Response to Planning application from Hertfordshire County Council (T and CP GDP Order 2015)

District ref: 3/24/1255/OUT
HCC ref: EH/21612/2024
HCC received: 11 July 2024
Area manager: James Dale
Case officer: Adrian McHale

Location
Land South Of A507, West Of A10 Buntingford

Proposal
Outline planning application for development of employment land (flexible use B2, B8, E(c) and E(g)), informal open space, associated works and infrastructure including a new access from A507, with all matters reserved except for access

Baldock Road Looking West from Proposed Access

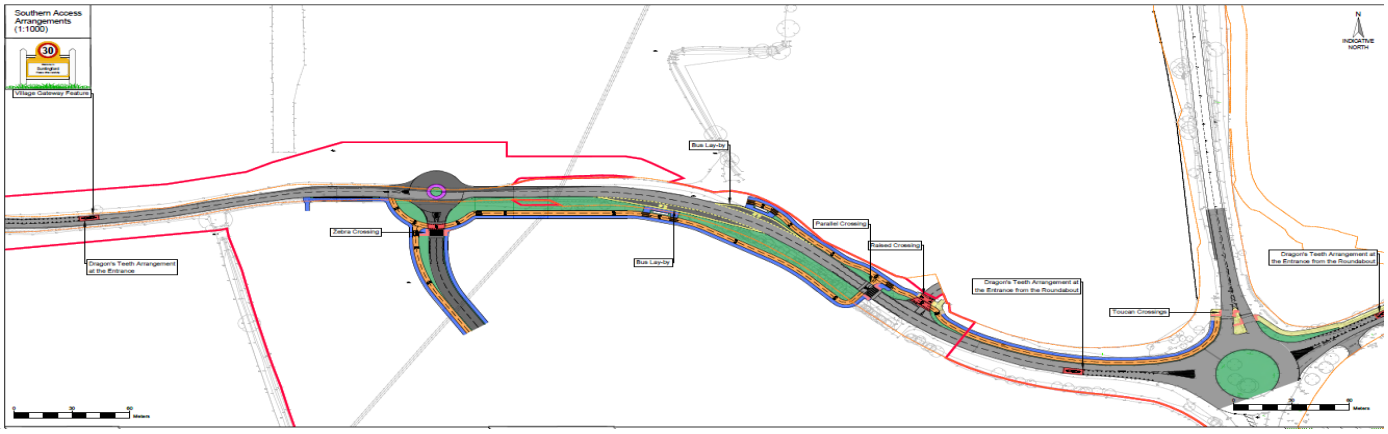
However, the A507, a Principle A Road, is subject currently to the National Speed limit (60mph) in this location and does not become subject to a 30mph speed limit until circa 600m east of the access, circa 125m east of the A10, in Buntingford when it is clear and naturally enforcing. The applicant/ Jubb proposes to relocate the 30mph speed limit sign circa 180m east of the proposed access to the site and reinforce it with 'Dragon Teeth' road markings. However, giving the nature of the road which is a sharp downhill in this location it is not considered that vehicles will naturally adhere to the proposed 30mph speed limit and the vehicle access would be unsafe. Furthermore, a roundabout access is unlikely to reduce vehicle speeds significantly prior to the proposed bus stops and toucan crossing to the east. Therefore, HCC's Speed Management Group (SMG) are unlikely to promote the TRO and thus the site could not be accessed safely.

Additionally, the relocation of the speed limit from within Butingford would necessitate a section of the 60mph A10 strategic link road and its roundabout with the A507 being subject to 30mph and this would be unsafe, unenforceable and unpractical for strategic traffic and would not be supported by the SMG either.

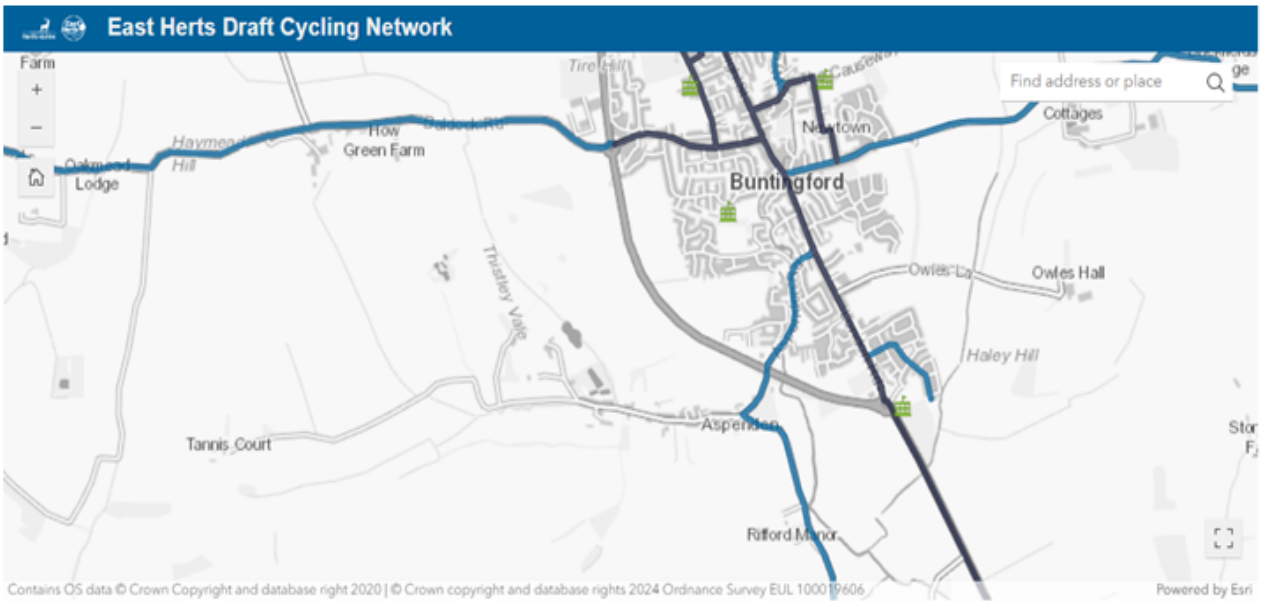
A review of the Framework Travel Plan by HCC's Travel Plan team has indicated matters that need to be resolved before the plan can be approved.

- Details of Travel Plan Coordinator (TPC) and its duties are missing;
- Secondary contact details must be provided in case TPC leave;
- An statement from the senior management is required in case developer sell and leave to inform HCC who to going to be responsible for implementing the TP
- monitoring must be multi modal not only questionnaire;
- monitoring of the site must happen for 5 yeas post full occupation;
- TP document needs to be reviews annually for 5 years post full occupation;
- An evaluation and support fee of £1200 per annum for 5 year post full occupation needs to be secured via s106 legal agreement
